# 2ND AND VIRGINIA

## RESPONSE TO BOARD GUIDANCE

#### 5 2ND AVE. INTERACTIVE ENTERTAINMENT SPACE

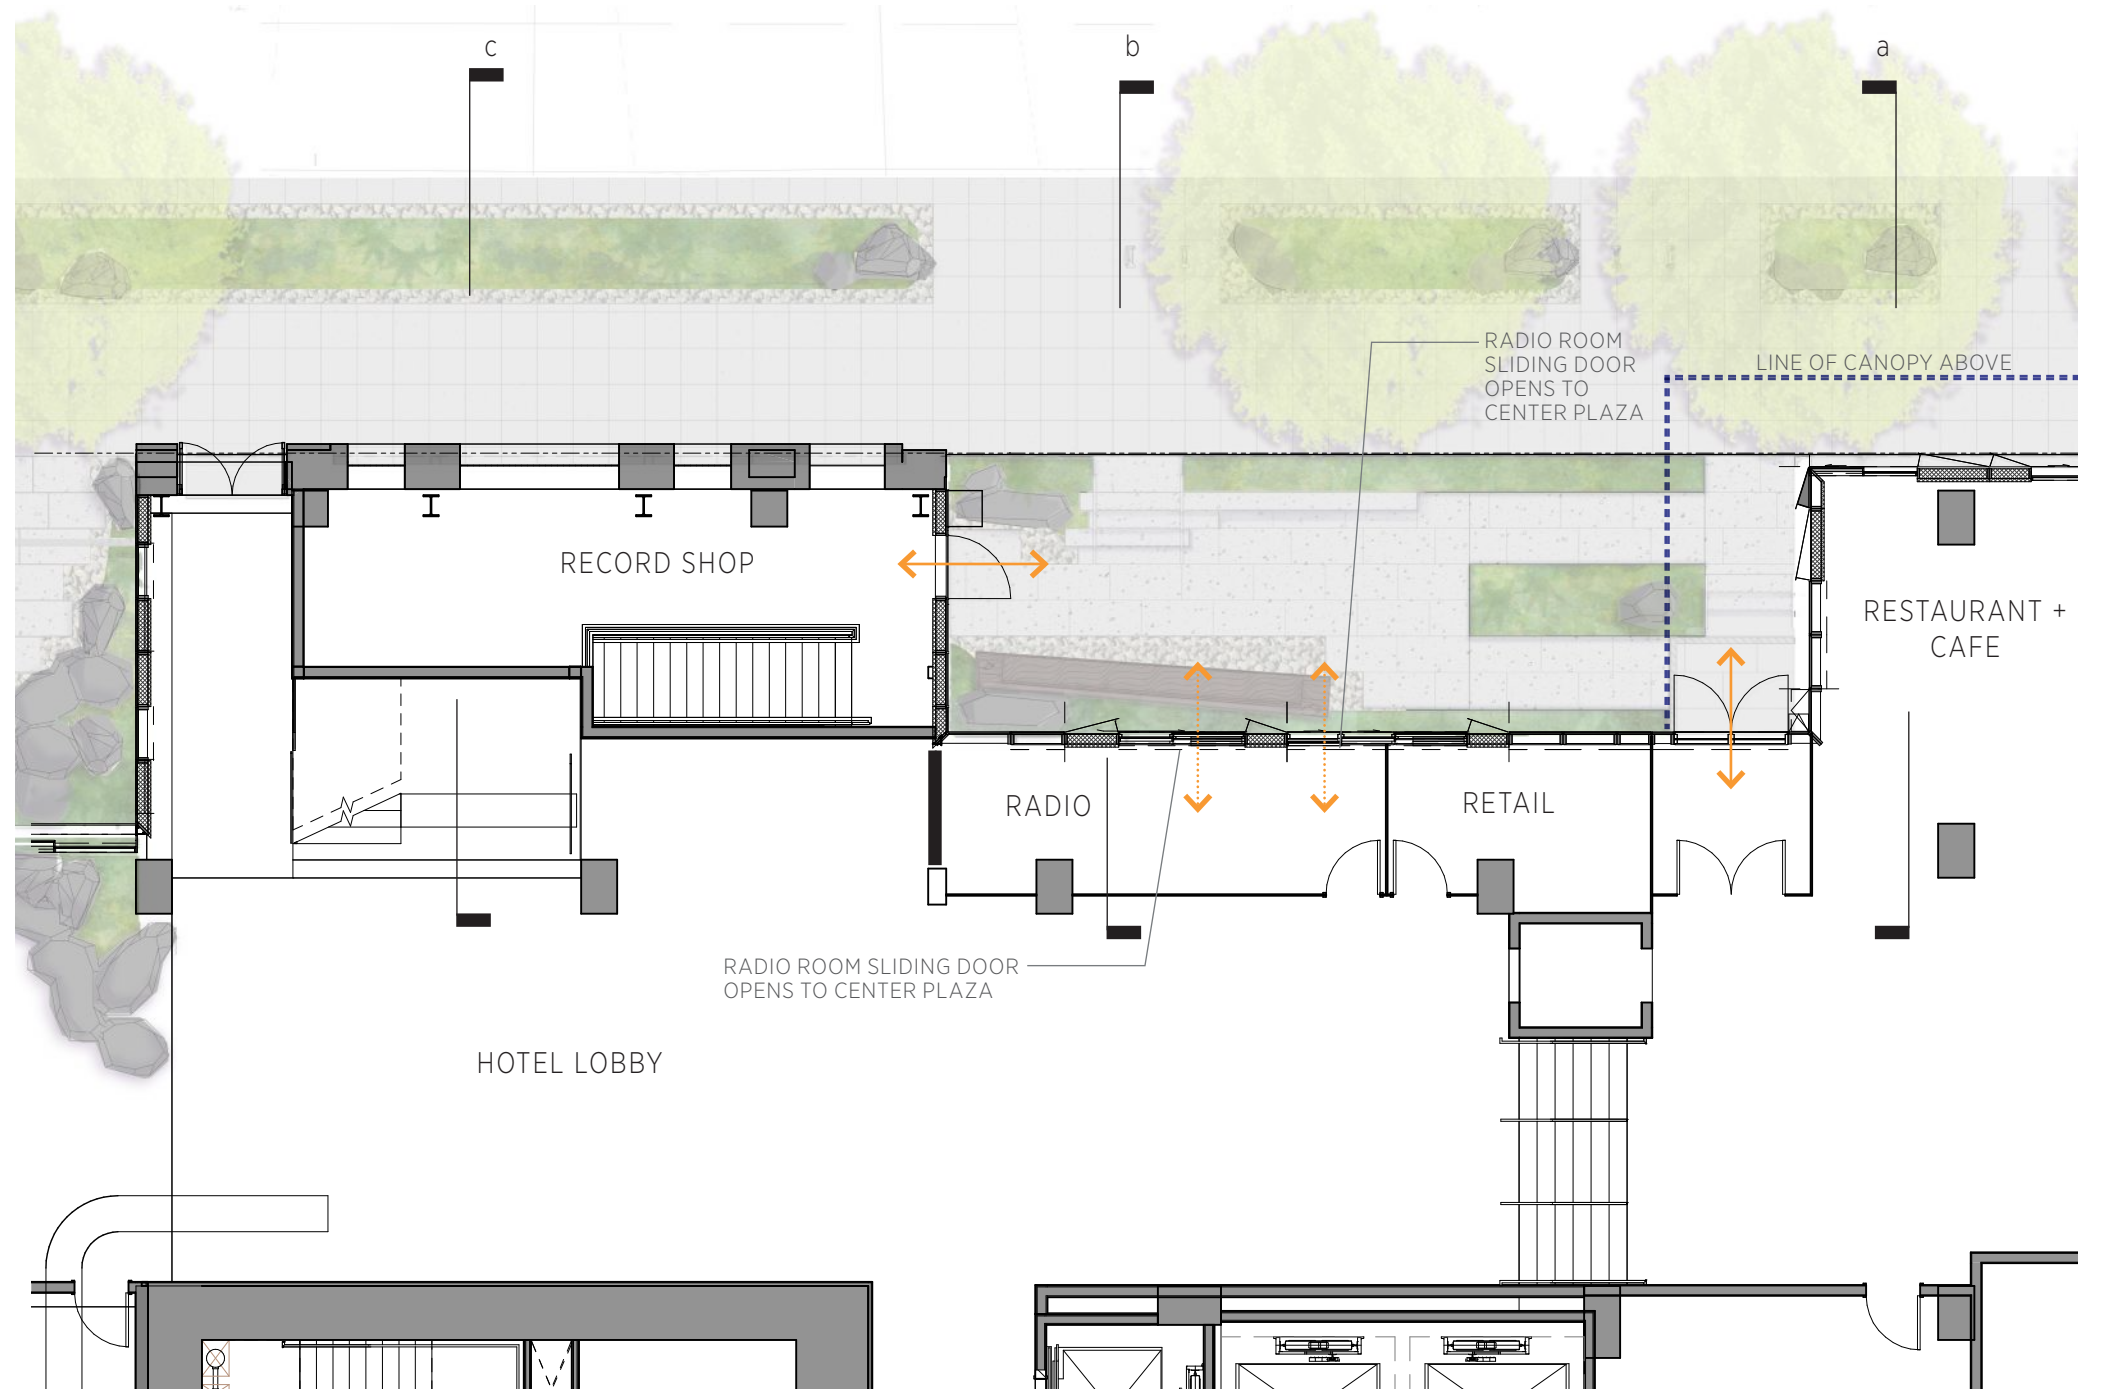
The Board was intrigued by the proposed interactive entertainment space (potential radio station use), and would like more information on what physical design features are proposed to support this use and space as an activated and engaging use along the street. The response should demonstrate how the design will remain engaging and active if this use changes.

The ground floor encourages foot traffic in and out of the building by bringing downtown amenities (a coffee stand and restaurant) to workers, visitors, and residents alike. Open space and seating, framed by lush native plantings, promote use of the plaza by the public and provides spaces to meet or relax while listening to live broadcasts from the Radio.

As well, by extending the sidewalk paving pattern into the plazas, the project widens the sidewalk at these Strategic moments of the ground floor, easing the transition. Finally, full height, sliding glass panels at the Radio strengthen the connection.

**6** ALLEY GLASS CORNER

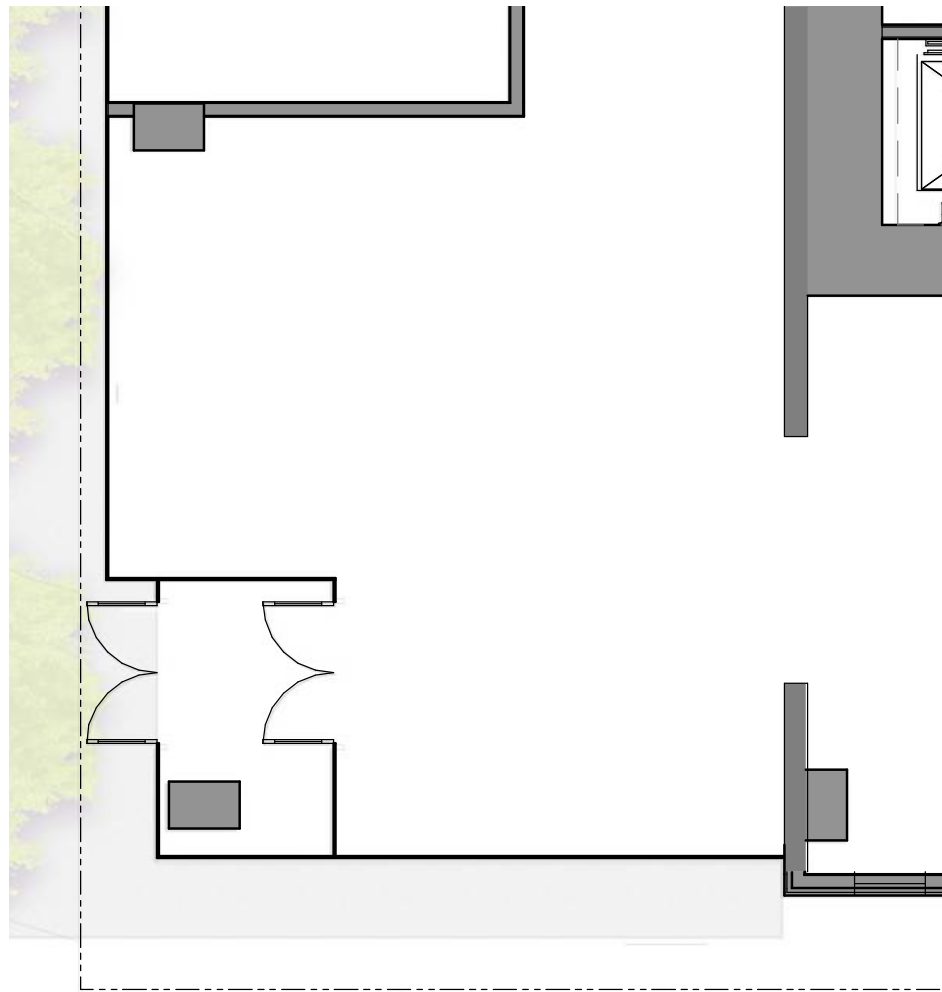
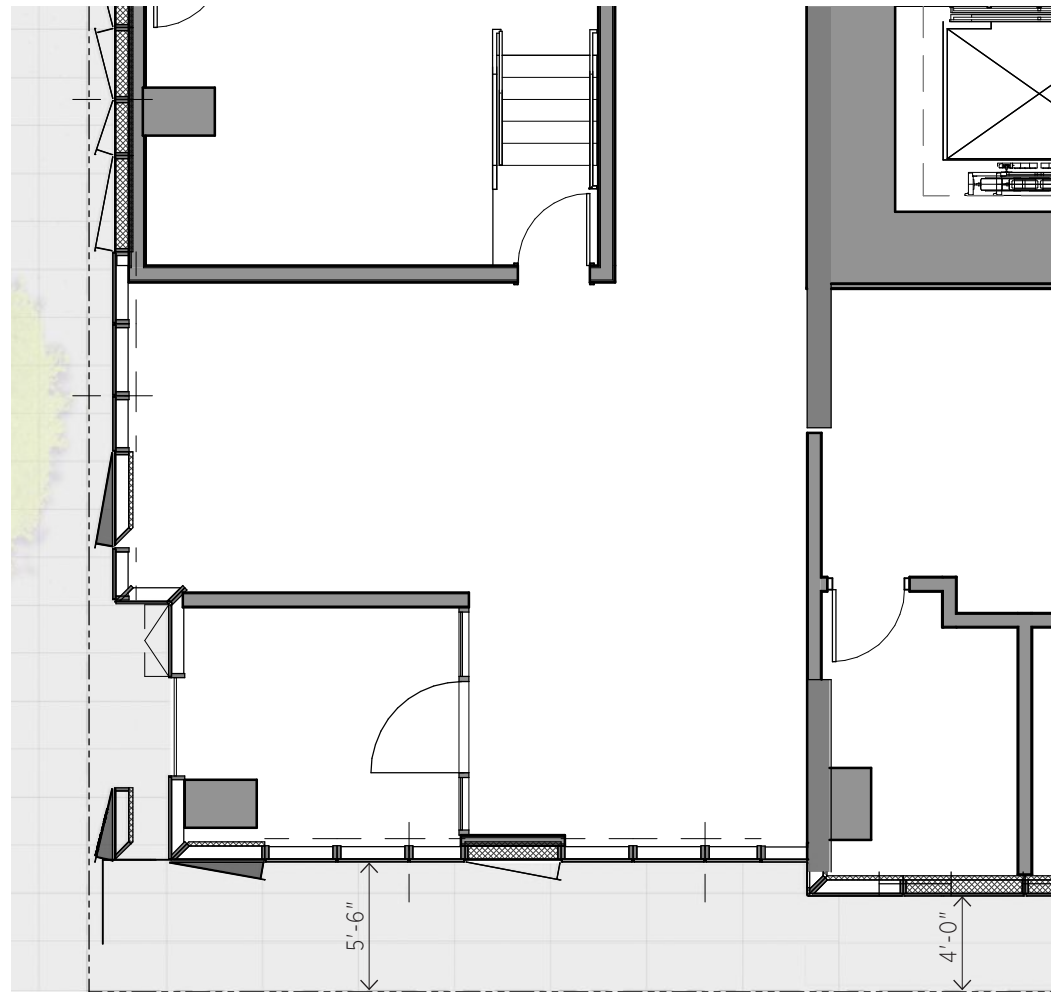
The Board gave guidance to further look at practicality of the glass corner and indicated whether this material would require bollards or column to protect the corner.

The design has evolved since EDG to remove the glass corner and have a solid, protected corner at the alley entry.

#### 7 ALLEY ARTICULATION

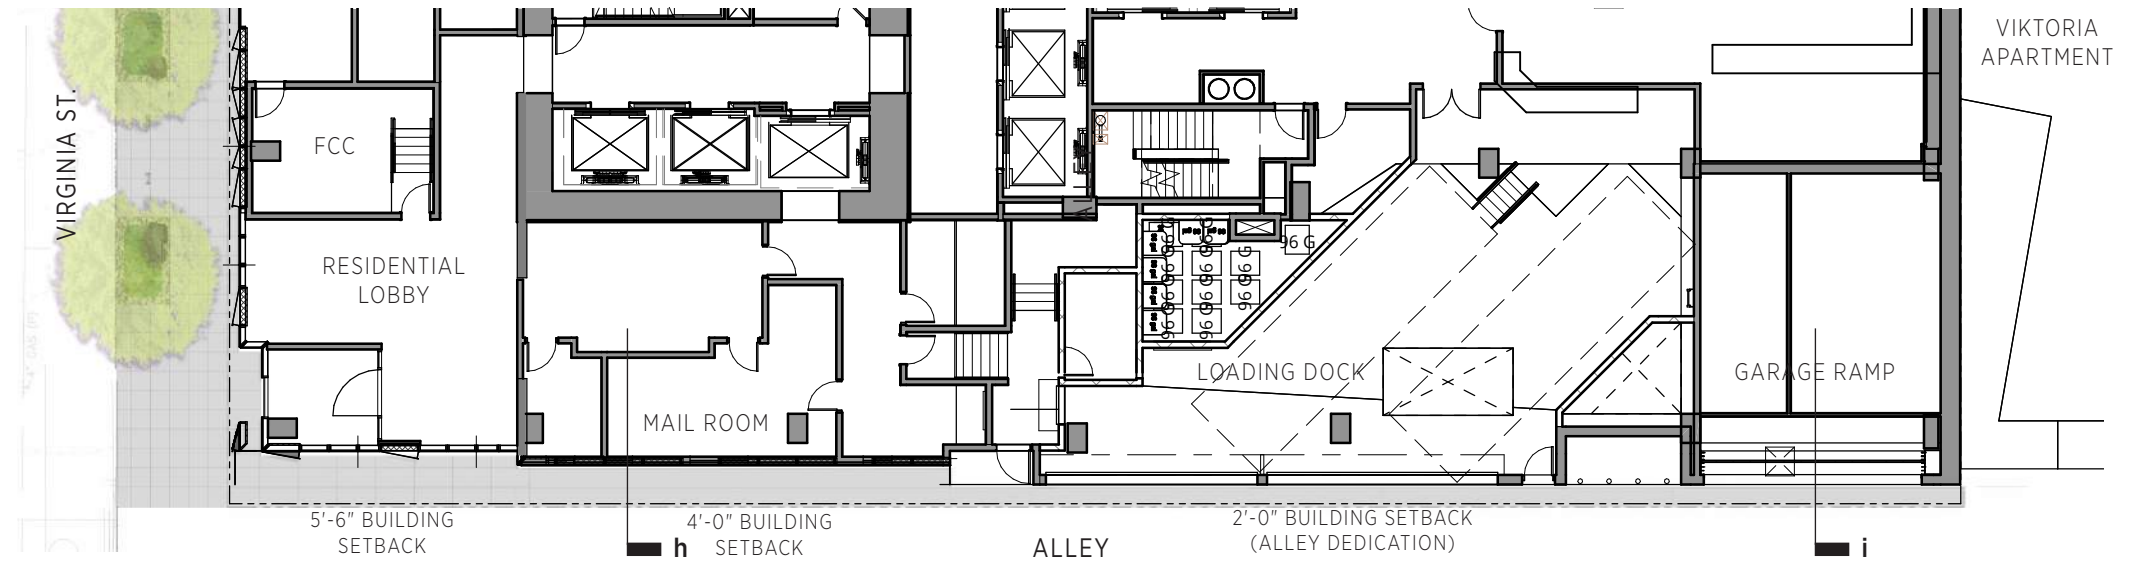
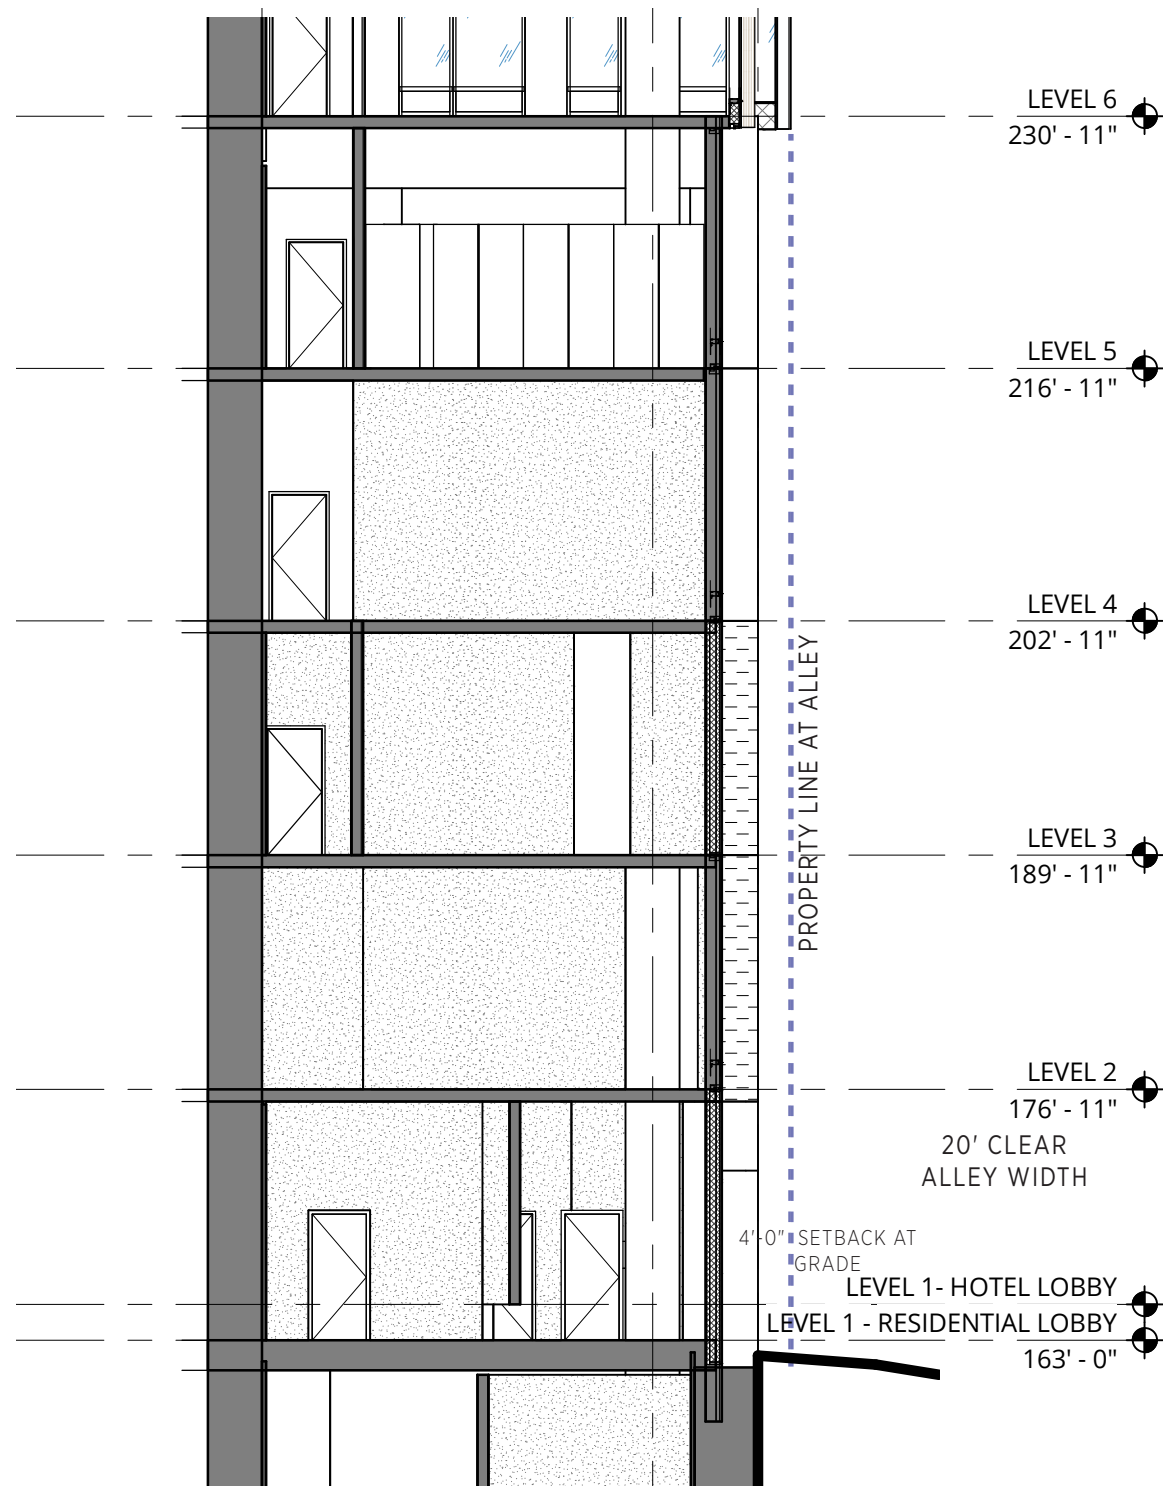
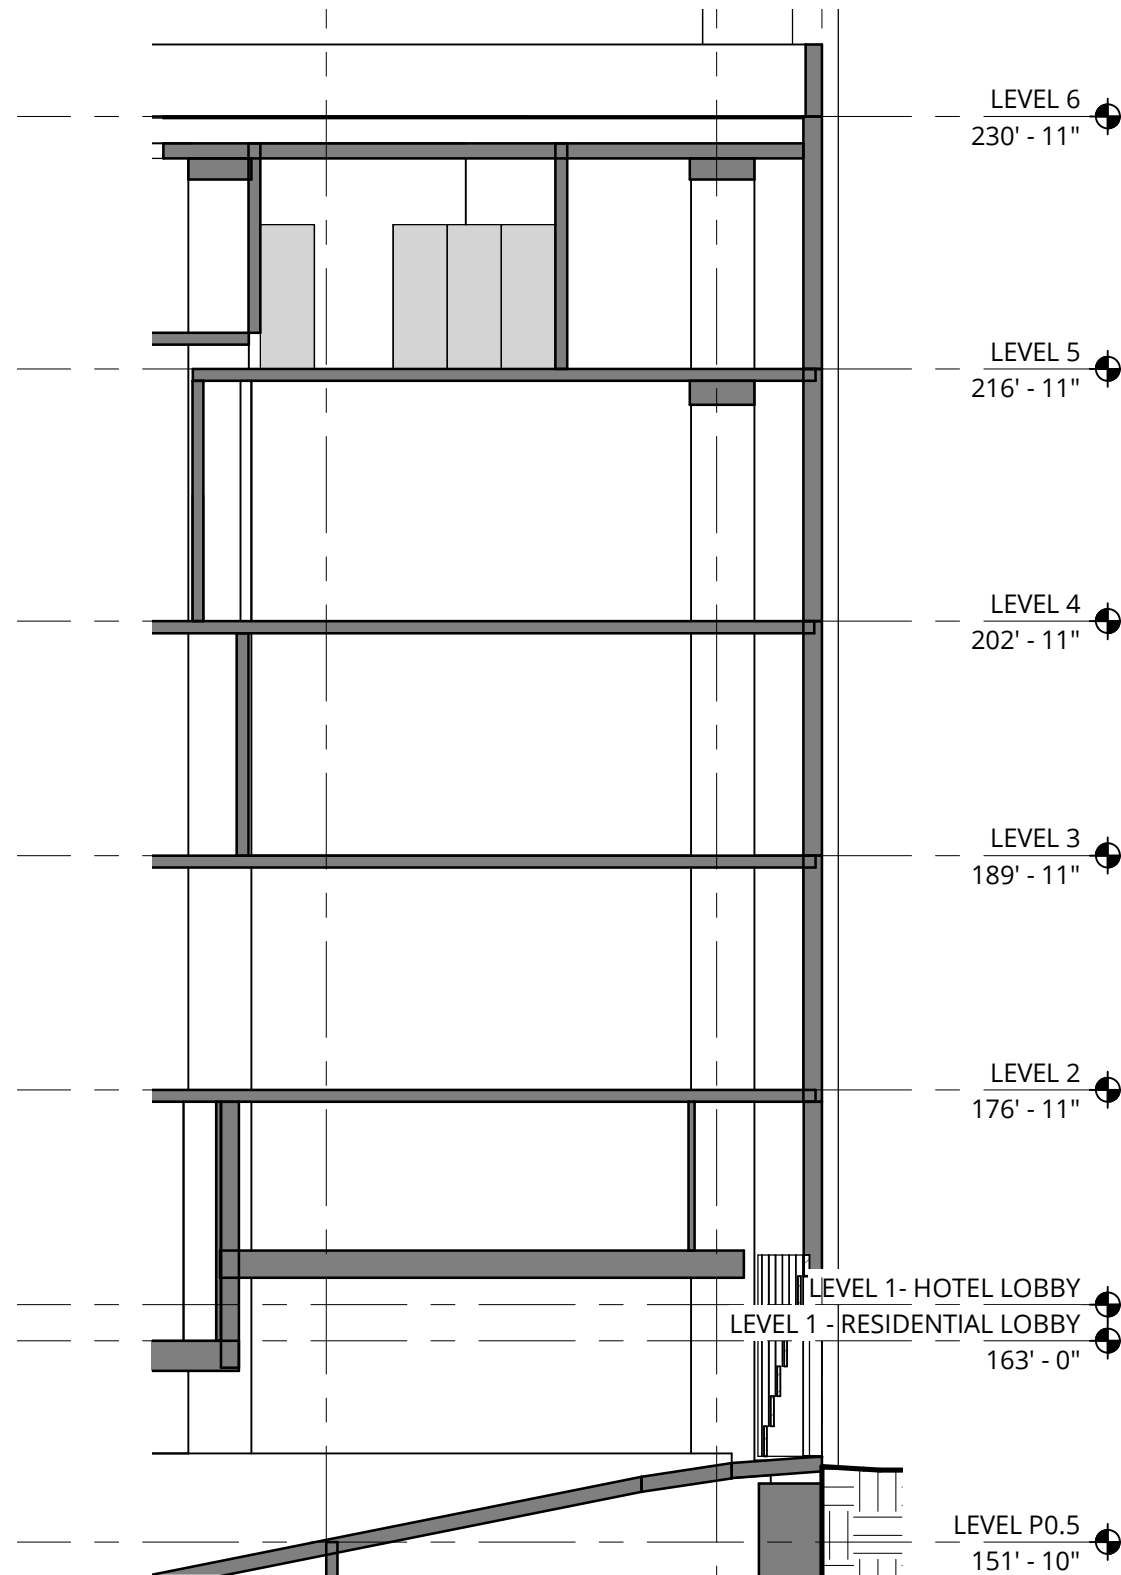
The Board acknowledged the utilitarian use of the southwest corner, however, requested more information on how the articulation of the alley will reinforce the overall tower concept. Specifically, the Board requested the design of the loading dock doors be considered.

The design of the alley is very much an extension of the overall tower concept. At the northwest corner, the tower articulation comes all the way down to the ground. Moving into the middle of the alley, the design transitions to capture the footprint of the Terminal Sales Annex before becoming more utilitarian on the south. The loading dock doors will be high-cycle, vertical stacking, sectional doors. An image is provided on the next page TSA facade provides new transparency at ground floor.
